**APPENDIX A
RECORDS OF COMMISSION MEETINGS**

Notes of meeting with City of Sydney Council

This meeting was conducted to inform the Commission's advice		
Meeting note taken by David Mooney	Date: 20 November 2017	Time: 9:00 am
Project: Martin Place Precinct – Stage 1 Over Station Development (SSD 8351)		
Meeting place: Level 3, 201 Elizabeth Street		
Attendees:		
Commission Members: Annabelle Pegrum AM Lynelle Briggs AO (Dial in) Professor Helen Lochhead	Commission Secretariat: David McNamara (Director) David Mooney (Team Leader)	Council: Graham Jahn Shannon Rickersey
<p>Items of discussion were generally limited to those aspects of the project for which the Minister for Planning had requested advice from the Commission:</p> <ul style="list-style-type: none"> • Council's tabled summary notes of its concerns at the meeting (Attached) • Council recommended: <ul style="list-style-type: none"> ○ maximum envelope for the northern tower be setback a minimum of 4m from the southern boundary with 50 Martin Place above the established street wall height. ○ maximum envelope for the northern tower be setback a minimum 4m from both Elizabeth Street and Castlereagh Street for the full length o

Figure 7: Pedestrian wind speed measurement locations with ratings for configuration B.2

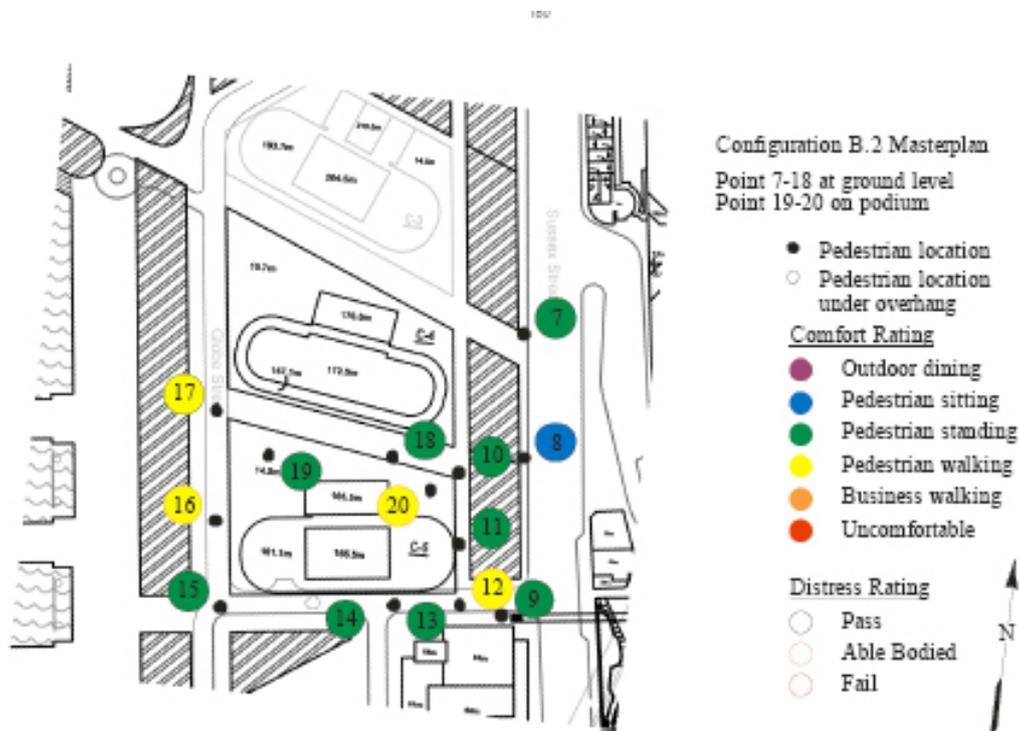
The conditions have proved to be more uncomfortable than predicted (pedestrian walking) and canopies and structures in an attempt to protect from the negative wind impacts in the public domain near Wynyard Walk.

Figure 14: Pedestrian wind speed measurement locations with comfort/distress ratings – Configuration C, full envelope of proposed buildings

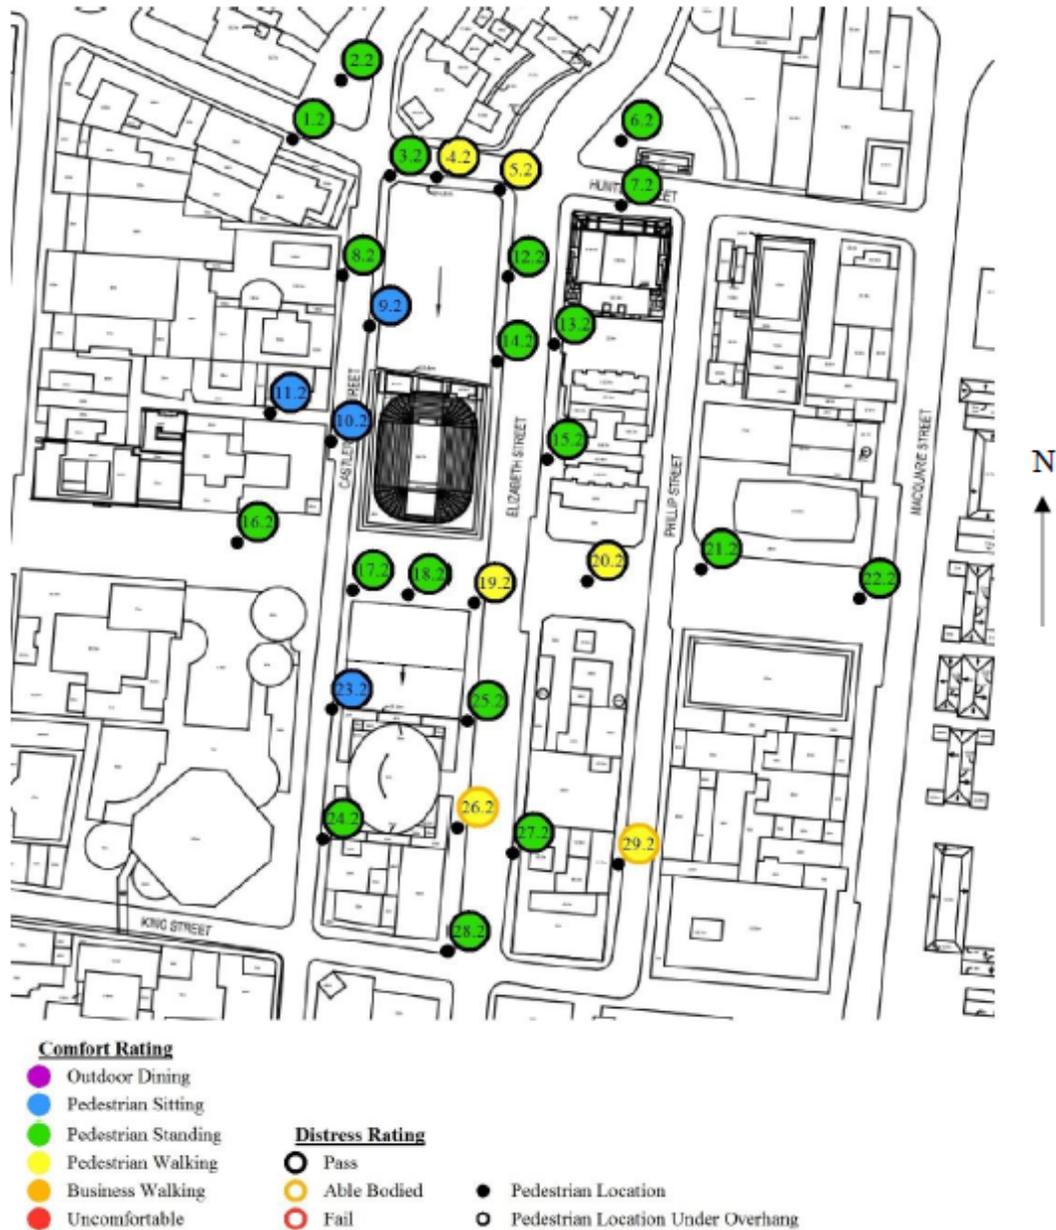
Overall, any new development should be **improving** the wind conditions experienced on the ground as the vision for Martin Place and elsewhere in the City is to produce comfort conditions on the ground. In at least 6 instances the wind conditions are modelled as being worse than existing.

Diagram illustrating urban design principles for tower level

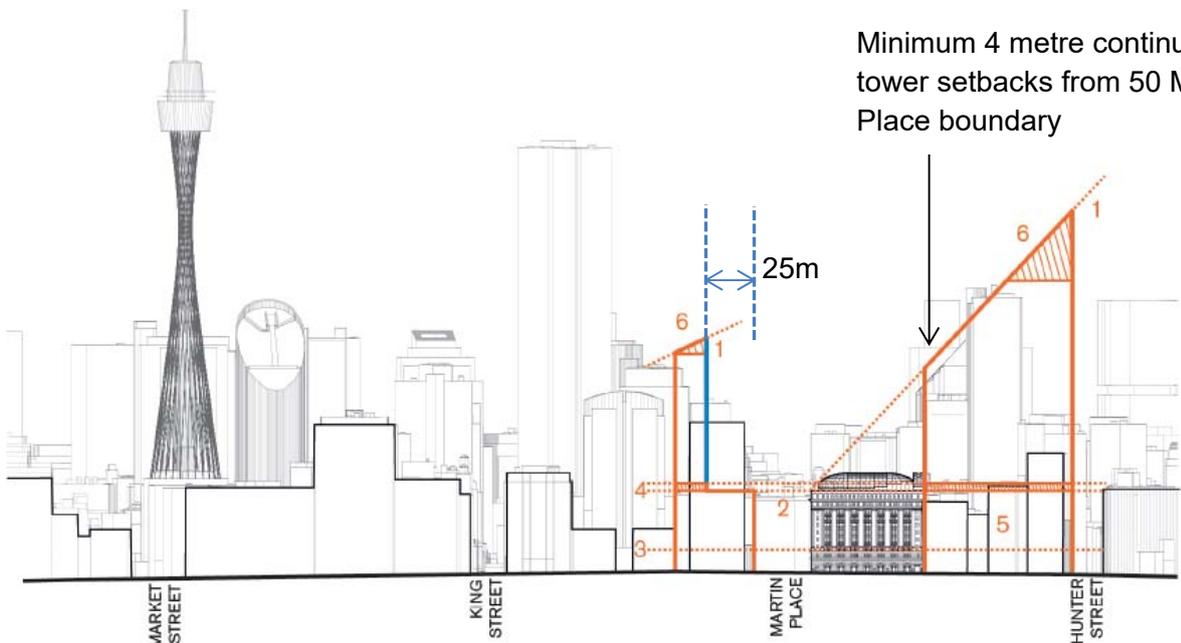
- It is recommended that the maximum envelope for the northern tower be setback a minimum of 4m from the southern boundary with 50 Martin Place above the established street wall height.
- It is recommended that the maximum envelope for the northern tower be setback a minimum 4m from both Elizabeth Street and Castlereagh Street for the full length of the new development.
- It is recommended that a street wall setback is required at the northern end of the northern building if the Stage 2 modelled wind conditions exceed existing conditions otherwise a street wall setback is not required.

Northern setback from podium dependent on Stage 2 design and predicted wind conditions – wind speed to be equal to existing conditions or better

Minimum 4 metre continuous tower setbacks above 50 Martin Place cornice

Minimum 4 metre continuous tower setbacks from 50 Martin Place boundary

A9. Wind impacts across the site continued

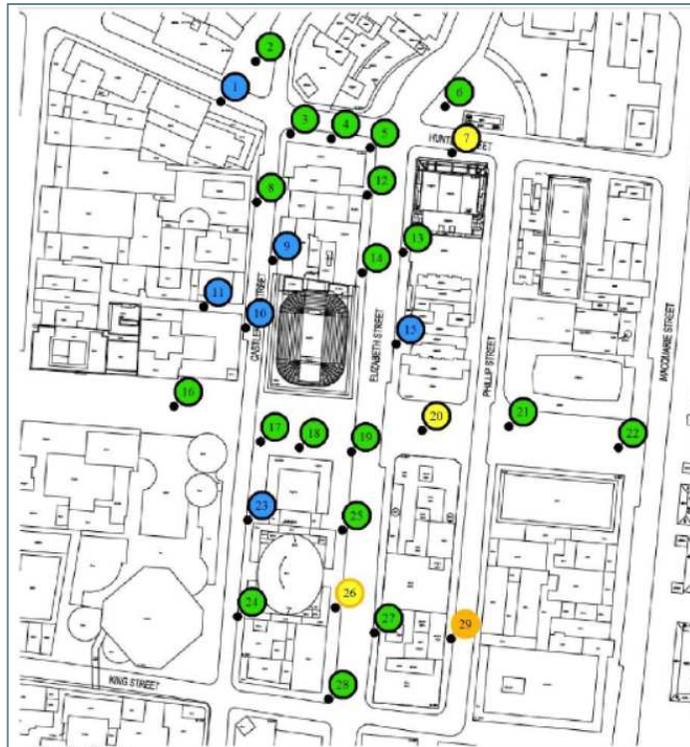
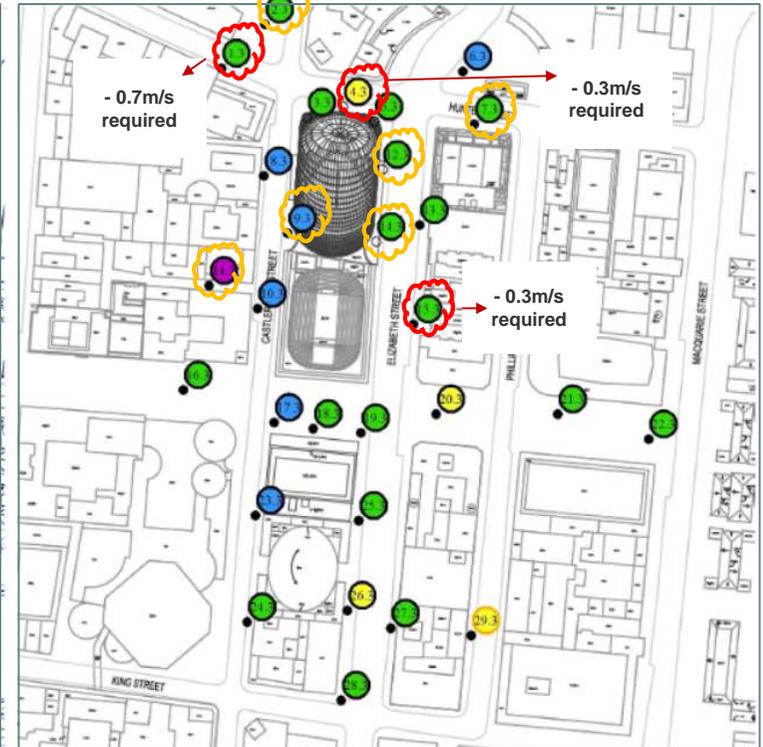
'The panel remains unconvinced about the proposed tower form - the panel seeks confirmation of no negative impacts on pedestrian amenity caused by wind effects on surrounding public spaces and footpaths' – Minutes DRP Meeting 22 August

North tower: The panel seeks confirmation of no negative impacts on pedestrian amenity caused by wind effects on surrounding public spaces and footpaths.

- > The panel seeks confirmation of no negative impacts on pedestrian amenity caused by wind effects on surrounding public spaces and footpaths.

Further information and a completed wind impact report is anticipated at a future review session in order for the panel to comment on whether or not this issue has been reasonably addressed.

- > Wind tunnel testing results show that wind conditions for the existing buildings, DCP compliant envelopes, and proposed building envelopes are generally consistent (refer to the CPP diagram illustrating results for the existing buildings and proposed building forms)
- > The proposed building forms (March design) delivered three (3) locations that are worse than the existing conditions. These are illustrated on the diagram and include two (2) locations to the east of the site with a negative impact of 0.3m/s and a location to the west in Hunter St with a negative impact of 0.7m/s

Proposed mitigation measures for Hunter Street

- > Wind tunnel testing shows that Hunter Street is most affected by horizontal north-east winds passing through the city rather than down drafts directly related to the form of the building
- > Podium setbacks and awnings will not mitigate horizontal wind effects
- > Proposed mitigation solutions currently being tested in wind tunnel are:
 - Sculpting of the tower form at high level
 - Detailed modelling of podium streetscape and fenestrations (e.g. columns)
